**Re Objections to Planning Application Reference No. 2016/2507/P, Proposed Development at 150 Haverstock Hill, London.**

Below are my comments to the planning application for change of use, part demolition and addition of a floor, rear roof terrace and solar panels on 150 Haverstock Hill.

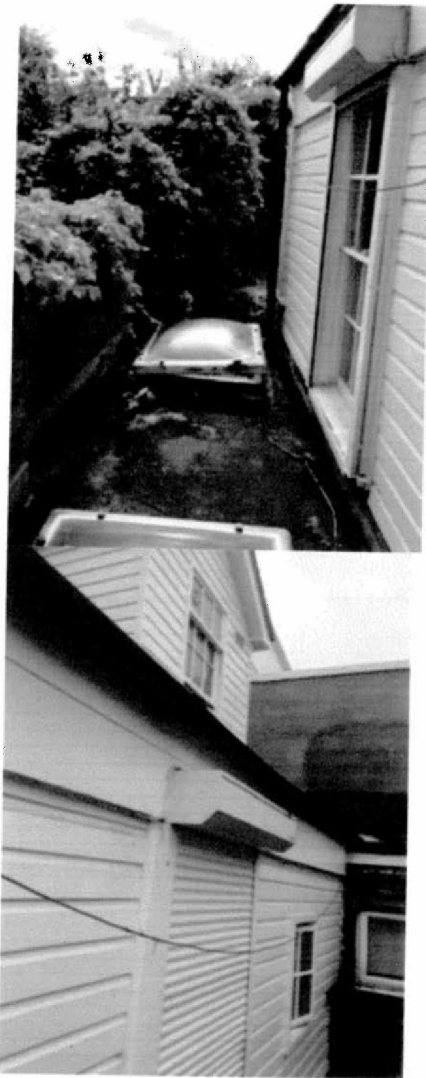
***The height of proposed structure incorrect vis-à-vis 150a - section AA on drawing HH14 06C***  
 The proposed total height of the two-storied dwelling is 5.3 metres. The height to the roof of 150 today is 3.33 metres for the part sharing a boundary wall with 150a (+ 0.13 m (uneven paving) from street to 150a/152 entrance and 3.2 meters from entrance floor to 150 roof, measured repeatedly with laser measure).

According to the drawing, the top of the new 150 roof would come up to a point where the terrace door frame can be seen fully, as is the top part of the door and a row of windowpanes can be seen partially above the new 150 roof. A row of windowpanes in the terrace door can be seen fully above the glass-screen. The height of the roofline in the planning documents is described as 'in line with the existing glazed doorway'.

The actual height from 150a flat-roof to the top of the terrace doorframe is 2.09 meters and to the top of the glass in the door 1.93m. As depicted on the drawing the height of the roof is about  $\frac{1}{4}$  below the top pane top edge = 8cm, this would mean height from 150a flatroof of i.e 1.85 metres. The flat roof is at this point 6-8 cm below (sloping towards the front drain) the roof of 150. Deducting this means the height relative to 150 roofline is 1.77-1.79 metres.

Adding this measure to the height of the current 150 roofline the new construction at 5.3 metres will thus be 18-20 cm higher than represented on the drawing, significantly underestimating what the actual impact on both 150a and 152 would be.

This means that all the drawings of how high the proposed new roofline of 150 will be vis-à-vis 150a (and 152) are incorrect and not showing the impact they will have in reality.

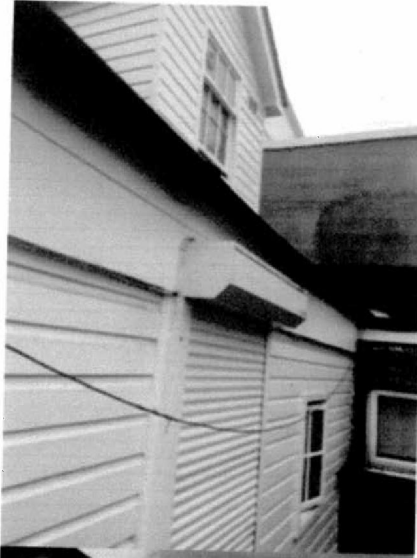
The back section of 150 is very narrow (about 2.5 metres). See photo below:

This means that the proposed roof terrace and big rear bedroom glass doors will open up next to almost all my windows (9 of the total of 12), the closest directly at the proposed glass wall and the furthest within a circle of +/- 2.5 metres in diameter horizontally and vertically, including all the windows at the back of the house, see below.

The windows in the photo above lead directly into the bedroom, workroom, living room and kitchen the three latter are open to each other. Several of these windows are open continuously April – October and on warm days in between.
